RESPONSE TO THE LOW-LEVEL BURIAL GROUNDS DANGEROUS WASTE PERMIT APPLICATION,  
REVISION 0, NOTICE OF DEFICIENCY (TSD: D-2-9)

Low-Level Burial Grounds Dangerous  
Waste Permit Application, Revision 0,  
NOD Response Table

LOW-LEVEL BURIAL GROUNDS  
NOTICE-OF-DEFICIENCY RESPONSE TABLE

FIGURE FOR COMMENT #31

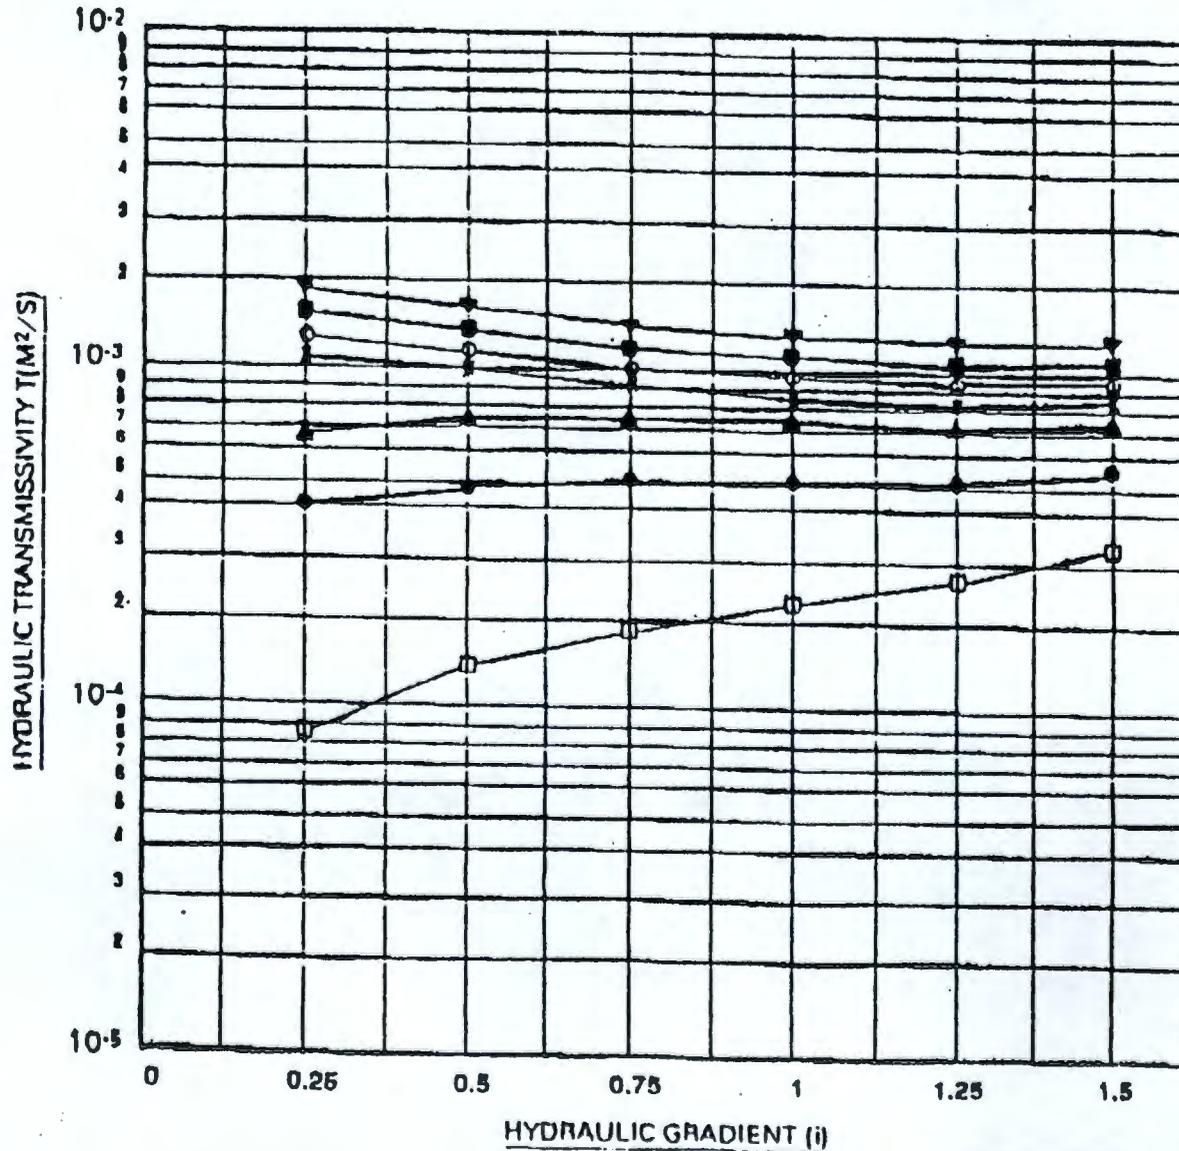
No.	Comment/Response	Ecology Concurrence
<u>Deficiency:</u>	Section 4.6.5.3.3 and 4.6.6.6.1, Weight of Overlying Material and Stability of Drainage Layers, Page 4-36 and 4-47.	
	The response fails to acknowledge Ecology's requirement to be provided with this documentation.	
	<u>Requirement:</u> The submittals noted in the response must be provided to Ecology's construction inspector or unit manager prior to use of the material.	
	<b>RL/WHC Response No. 4:</b> The handling of construction inspection and other interfaces with Ecology regarding construction are being addressed as part of Hanford Facility Permit discussions.

FIGURE FOR COMMENT # 146

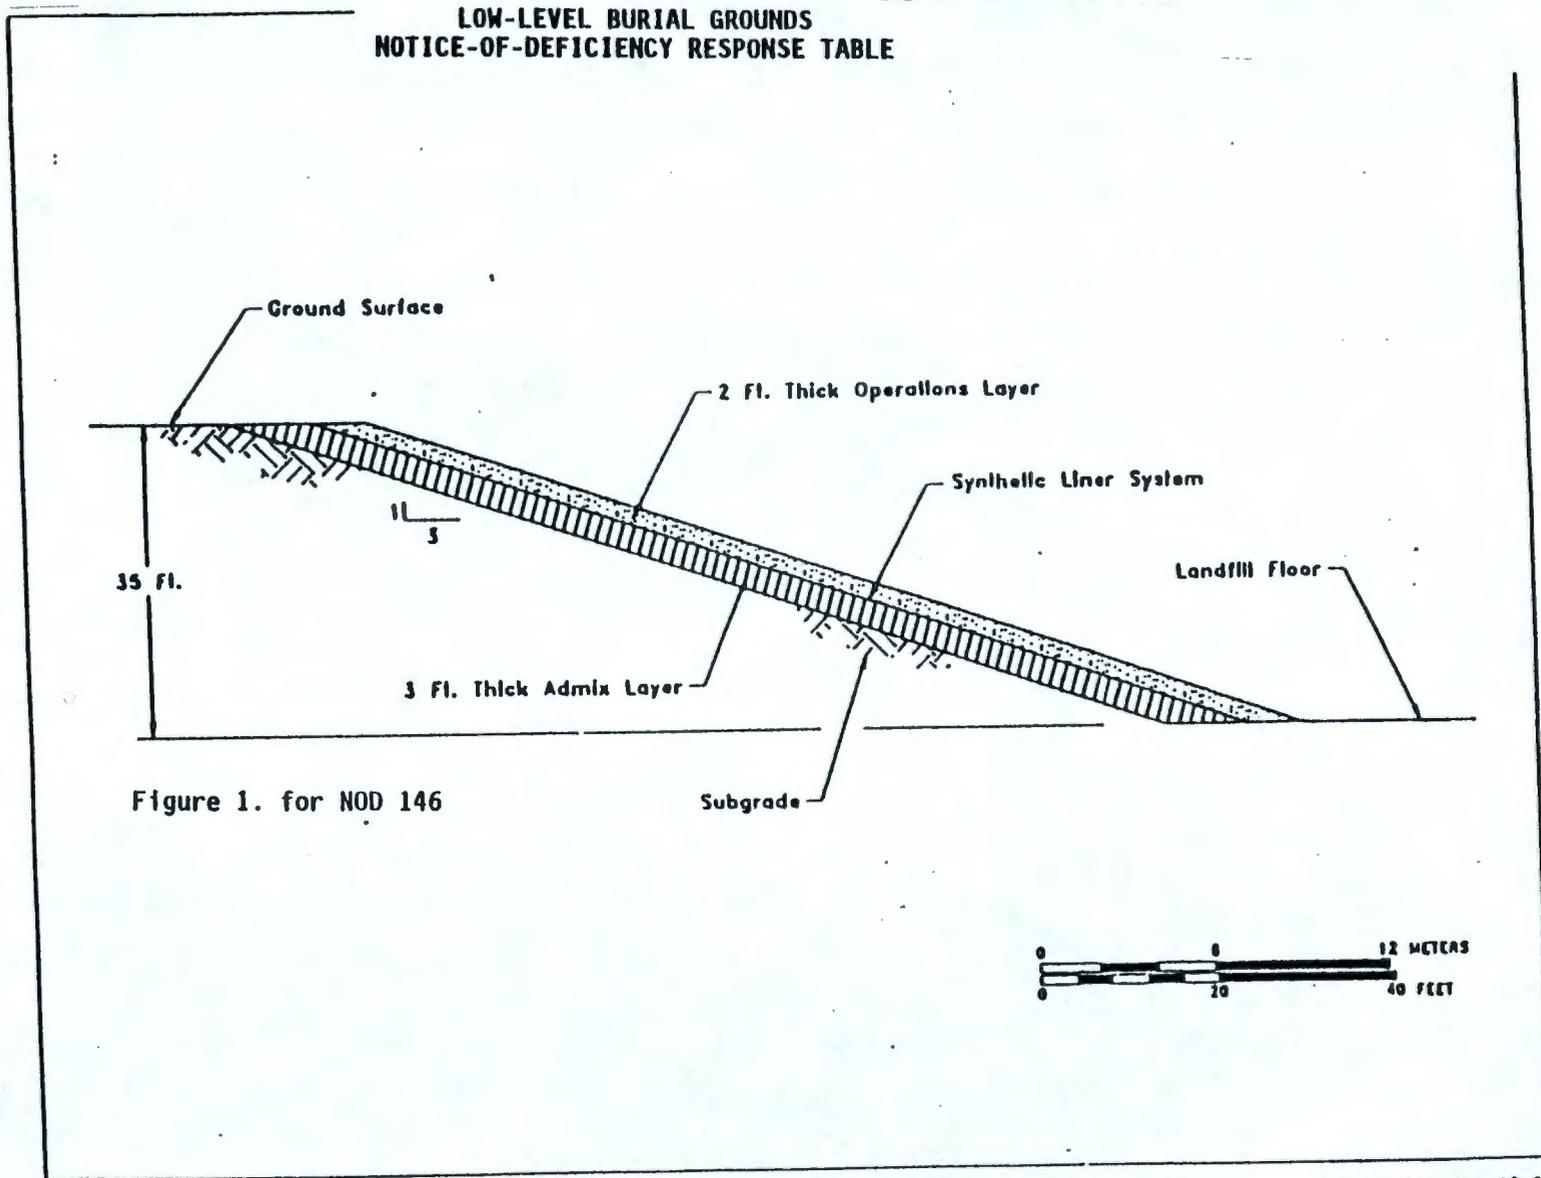
No.	Comment/Response
	<p>for an FS-2 and a 4H:1V slope along with Energy's recognition that a slope failure may prohibit further use of the landfill if Ecology does not accept the repair work of a failed slope.</p>
DOE-RL/WHC Response No. 2:	<p>This comment raises a number of issues. We are also concerned with safety, but believe that 3H:1V sideslopes will perform satisfactorily. The following thoughts are offered to support this conclusion.</p>
	<p>The assumed strength properties and corresponding factors of safety used for the W-025 design are summarized in the attached table titled "Summary of Slope Stability Design Values". These values are based on laboratory testing and are residual strength values, a conservative approach. It may be seen that the factors of safety for the soil/geotextile interface are below Ecology's proposed value of 2. However, the apparent cohesion (see attached test data sheet, "Sandy Soil vs Texnet Geocomposite") was ignored in this analysis to be conservative. If the cohesion is included, the static and dynamic factors of safety increase to 4.3 and 3.1, respectively. It should be noted that failure along this interface means that the operations layer would slide; this would not affect the liner system and consequently would have no impact on landfill performance. As discussed in more detail below, the buttressing effect of the toe of the operations layer and of the waste itself was not considered, again a conservative approach. For these reasons, the strength of this interface is considered adequate.</p>

<p>The other factor of safety in the Design Values table that is less than 2 is the dynamic factor of safety for the subgrade, which is 1.7. As discussed in more detail below, a factor of safety of 1.1 is considered adequate for dynamic loading conditions. Also discussed below, a dynamic factor of safety lower than the static factor of safety is appropriate.</p>
	<p>Additional stability analyses have been performed that do include the buttressing effects of the toe of the slope. These analyses and results are described in the attached "Supplement 1." This analysis confirms and extends the results of the original W-025 design analyses, and again indicates that relatively high factors of safety, both static and dynamic, can be achieved using reasonably expected material strengths.</p>
